CERTIFICATE OF APPROPRIATENESS

Property: 1446 Rutland Street, Lot/Tracts 33, 34A, Block 154, Houston Heights Subdivision. The property includes a 3,462 square foot two-story brick commercial building situated on a 6,600 square foot interior lot.

Proposal: Alteration – Roof

ROOF DETAILS

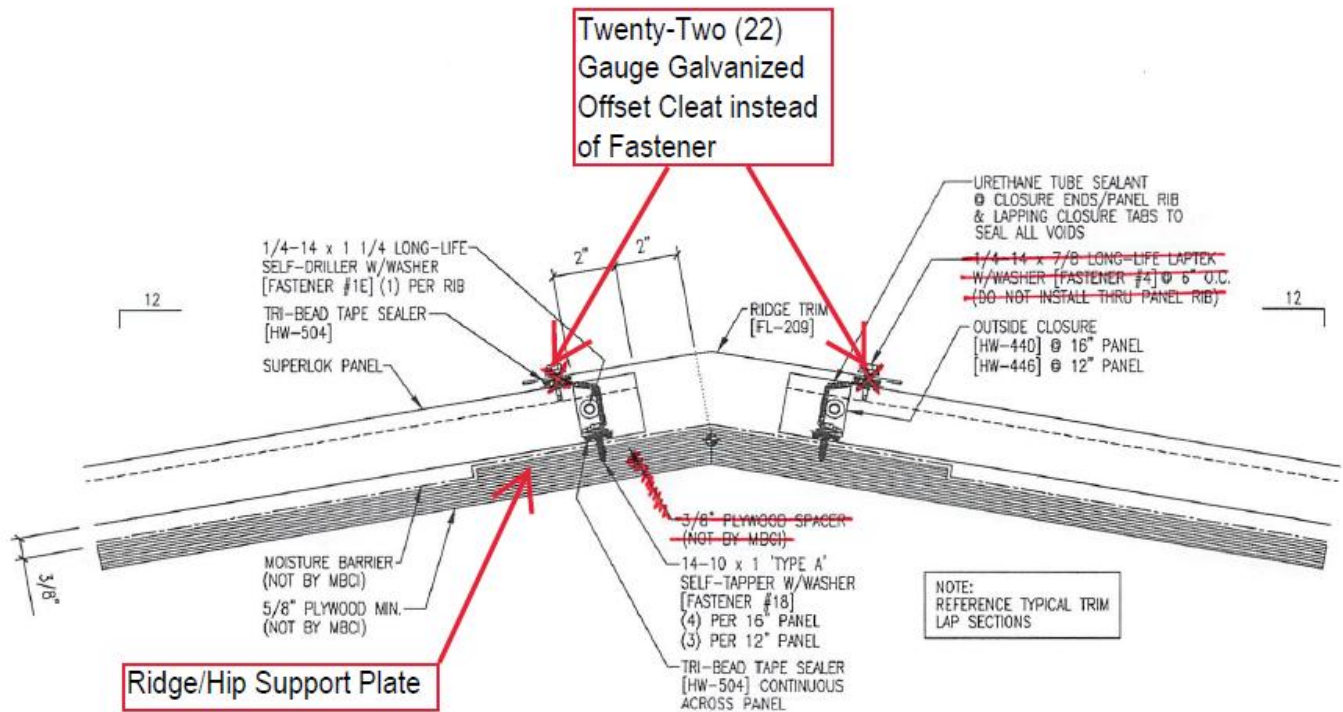
The applicant is proposing to replace the existing composition shingles on both the main house and the garage apartment with a standing seam metal roof. There are no proposed changes to the pitch or structure.

SuperLok® is a mechanically field-seamed, vertical leg standing seam roof system that combines a 2" tall slim rib with exceptional uplift resistance. It is available in both 12" and 16" widths. SuperLok® has been designed to withstand the most rigorous weather conditions. SuperLok® can be installed directly over purlins or bar joists. SuperLok® does not require a solid substructure for support. SuperLok® panels are standard with striations to minimize oil canning.
